HISTORIC AND DESIGN REVIEW COMMISSION

June 21, 2017

HDRC CASE NO: 2017-276
ADDRESS: 2202 BROADWAY
LEGAL DESCRIPTION: NCB A-6 BLK LOT S IRRG 80 FT OF W TRI 228 FT OF A-1 ARB B-2
2202 BRDWAY
ZONING: C-3NA,NCD-9, RIO-2
CITY COUNCIL DIST.: 2
APPLICANT: Peter French/Rising Barn
OWNER: Eduardo Modesto/RAMCO
TYPE OF WORK: Installation of a pre-fabricated structure
REQUEST:

The applicant is requesting a Certificate of Appropriateness for approval to install a prefabricated structure on the lot at 2202 Broadway.

North (front) Elevation w/ Sliding Door, Window

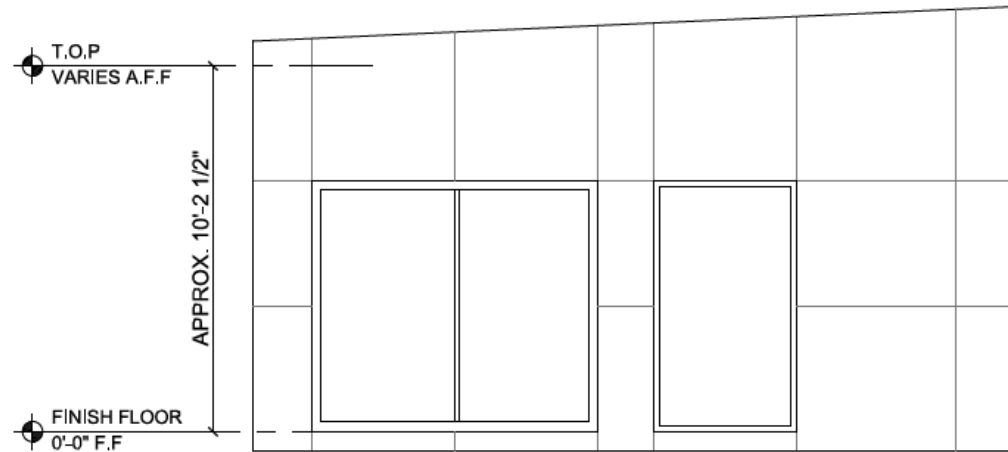
- c. ORIENTATION – The applicant has proposed to install a 200 square foot structure near the southeastern corner of the lot. The applicant has proposed to orient the entrance of the structure toward the interior of the lot. Per the UDC Section 35-673(b)(1)(a), two or more buildings on a site should be clustered to create open courtyard spaces. Additionally, the UDC Section 35-673(b)(1)(b) notes that primary entrances should be oriented toward the street. The applicant's proposal is not consistent with the UDC Section 35-673(b)(1)(b) in regards to entrance orientation.

- i. That the applicant install a primary entrance or orient the structure so that the primary entrance front Broadway or Appler.
- ii. That the applicant install fenestration on the current south elevation that currently lacks no elements that separate the façade.
- iii. That the applicant screen the mechanical equipment on the rear (south elevation).

Building Elevations:
West Elevation w/ Single Window
South (rear) Elevation

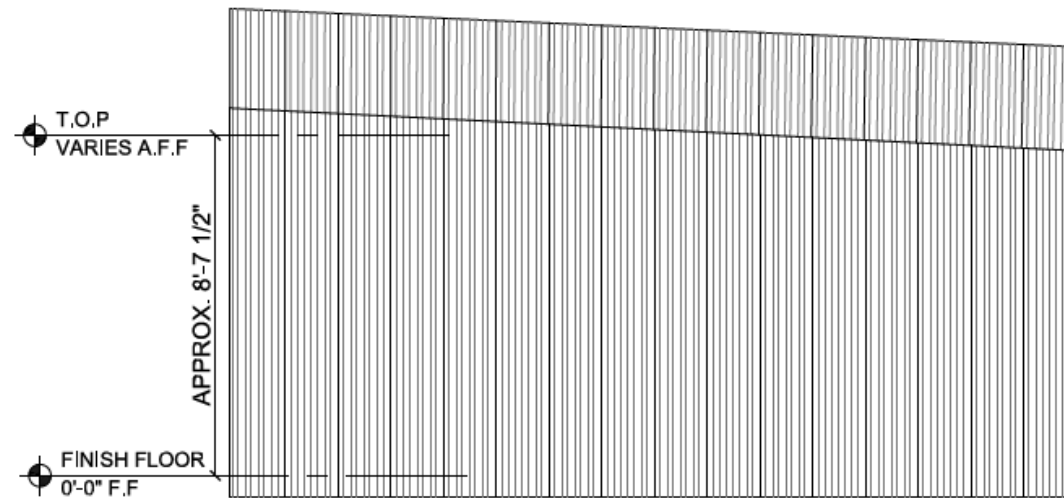
- e. FAÇADE ARRANGEMENT – The rear of the structure, which fronts Appler features no façade separation or fenestration. This is not consistent with the UDC Section 35-674(e)(2).

- i. MECHANICAL EQUIPMENT – Per the UDC Section 35-673(m) and (n), Buffering and Screening should be used to screen mechanical and service equipment from the public right of way. The proposed structure features a utility box on the rear façade that faces Appler. This is not consistent with the UDC.
